**ICDF 60% Design Components —  
Document Review, Comment, Resolution Table – IDEQ**

# ICDF 60% DESIGN PACKAGE

## DOCUMENT REVIEW, COMMENT, RESOLUTION LIST - IDEQ

DOCUMENT TITLE: 60 Percent Design Components, ICDF Master Table of Documents, Draft DOE/ID-10925

**Figure 1-1.** Evaporation Pond Lining System Sections.

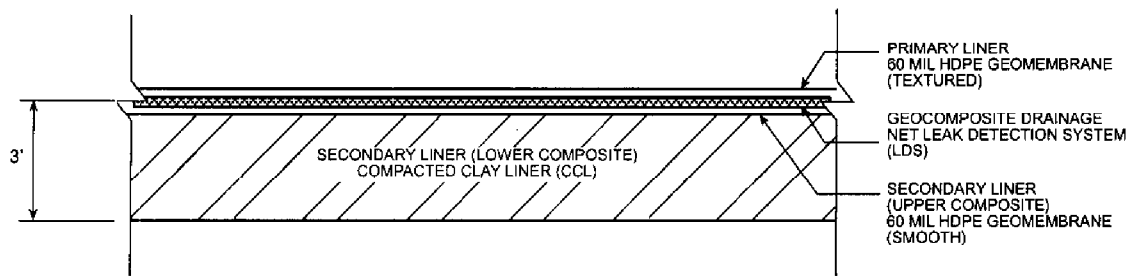
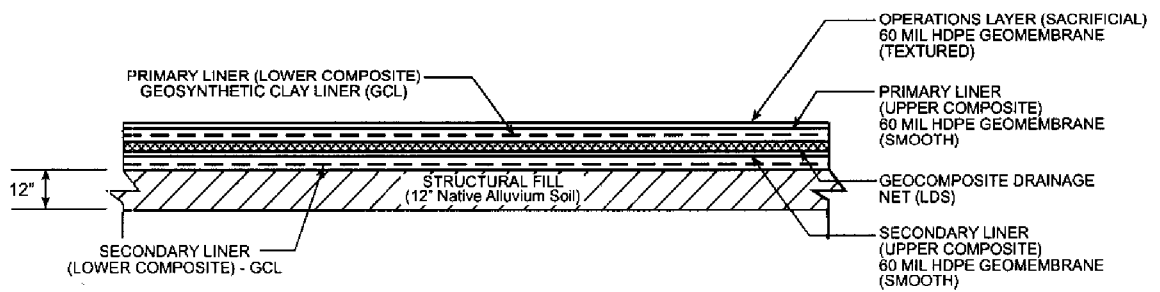
ITEM	SECTION/ FIGURE/ APPENDIX	PAGE	COMMENT	RESOLUTION
				Hsuan, et al (1997). "Effects of Freeze-Thaw Cycling on Geomembrane Sheets and Their Seams". Proceedings Geosynthetics '97. IFAI. Pp. 201-216
85	Sec 1.1	1	Please provide Figure 1-1.	Fig 1-1 will be included in the revised 60% document. It is also attached to the comment response.
86	Sec 1.2	2	The citation 40 CFR 262.221 (c) is incorrect and should be 264.221 (c).	Comment will be incorporated in final 60% submittal.
87	Sec 2.2.1	6	Please provide Figure 2-1.	Fig 2-1 will be included in the revised 60% document. It is also attached to the comment response.
88	Sec 2.2.1.1	8	Please provide a description of how compliance with 40 CFR 264.222 will be met and provide the anticipated Action Leakage Rates for the evaporation ponds. (Giroud and Bonaparte discuss that "flow of liquids through geomembranes is not governed by Darcy's Law" - yet ALRs in EPA regulations assume Darcy's Law).	<p>It should be clarified that the of the intent of this EDF was not as a design document for the EP lining system. It was intended as demonstration of the equivalency of a proposed alternative lining system for the EP.</p> <p>In regards to compliance with 40 CFR 264.222: this regulation requires the regional administrator to approve an ALR and monitoring to determine if the ALR has been exceeded. Discussion of the monitoring of leakage rates from the EP was not the intent of this EDF. Monitoring for the ICDF will be included as part of the O&amp;M package in the 90% RD/RA submittal.</p> <p>Action Leakage Rate (ALR) for the EP will be provided in the 90% RD/RA work plan submittal. Calculations will be similar to those presented for the landfill in Section 4 of EDF-269 (Leachate Generation Study). Generic guidance provided by EPA (1992) for surface impoundments is 1000 gpad. Preliminary calculations following the guidance provided in 264.222 (maximum flow rate that the LDS can remove without fluid head on the liner exceeding 1 foot) is 2000 gpad. This is based on the specified transmissivity of <math>3 \times 10^{-4} \text{ m}^2/\text{s}</math> for the drainage composite in the LDS and</p>
